Project	IEEE 802.16 Broadband Wireless Access Working Group < http://ieee802.org/16 >	
Title	Technical and editorial amendment of 802.16-2004 facilitating license-exempt and uncoordinated band operation	
Date Submitted	2006-01-03	
Source(s)	Paul Piggin Cygnus Communications 2075 Las Palmas Drive Carlsbad CA 92009	Voice: 760 448 1984 Fax: 760 448 1989 ppiggin [at] cygnuscom.com
Re:	Call for Contributions, IEEE 802.16h Task Group on License-Exempt Coexistence, IEEE 802.16h-05/023	
Abstract	This document contains suggested amendments to the working draft and base standard to facilitate a framework from which MAC enhancements for license-exempt and uncoordinated system operation can be developed.	
Purpose		
Notice	This document has been prepared to assist IEEE 802.16. It is offered as a basis for discussion and is not binding on the contributing individual(s) or organization(s). The material in this document is subject to change in form and content after further study. The contributor(s) reserve(s) the right to add, amend or withdraw material contained herein.

Technical and editorial amendment of 802.16-2004 facilitating license-exempt and uncoordinated band operation

Figure xyz Representation of 'Channel Centre Frequency' calculation.

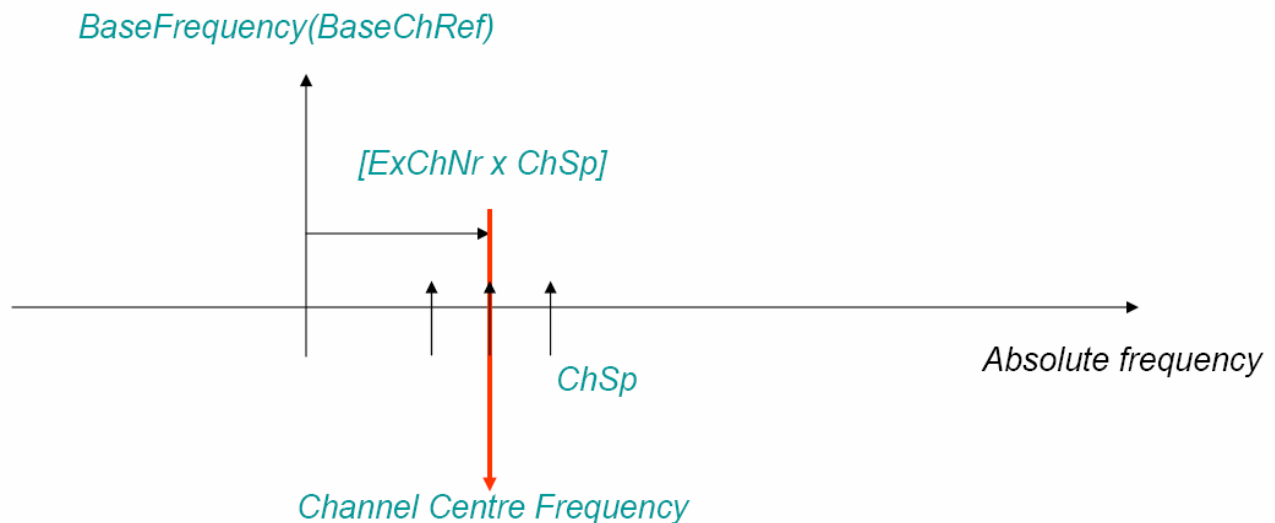
In summary the definition of the *Channel Centre Frequency* is:

$$\text{Channel Centre Frequency [MHz]} = \text{BaseFrequency(BaseChRef)[MHz]} + (\text{ExChNr} - [\text{MHz}] \cdot \text{ChSp} [0.01\text{MHz} + 10\text{kHz}]) \quad [\text{xxx}]$$

This is shown in a graphical representation in figures [xyz].

Figure 219—Illustration of OFDMA frame with multiple zones

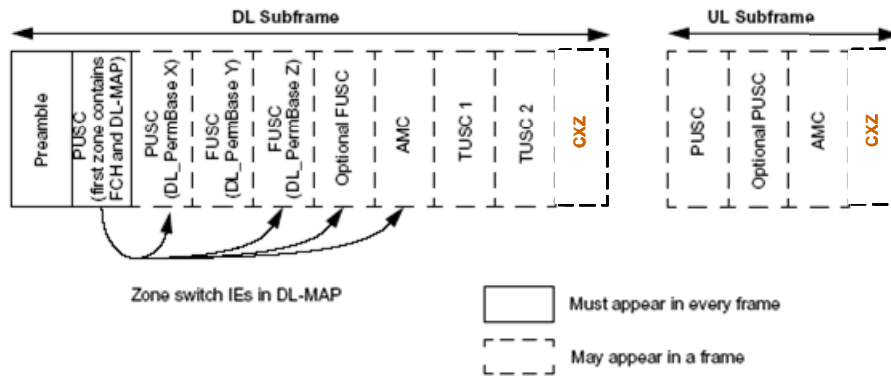
In support of the material added in section 6.4.2 make the following changes to the OFDMA PHY specification in figure 219 in section 8.4.4.2.

The OFDMA frame may include multiple zones (such as PUSC, FUSC, PUSC with all subchannels, optional FUSC, and AMC, CXZ, TUSC1, and TUSC2), the transition between zones is indicated in the DL-Map by the

STC_DL_Zone IE (see 8.4.5.3.4), [CXZ_DL_IE](#) (see 8.4.5.3.11), or AAS_DL_IE (see 8.4.5.3.3). No DL-MAP or UL-MAP allocations can span over multiple zones. Figure 219 depicts the OFDMA frame with multiple zones.
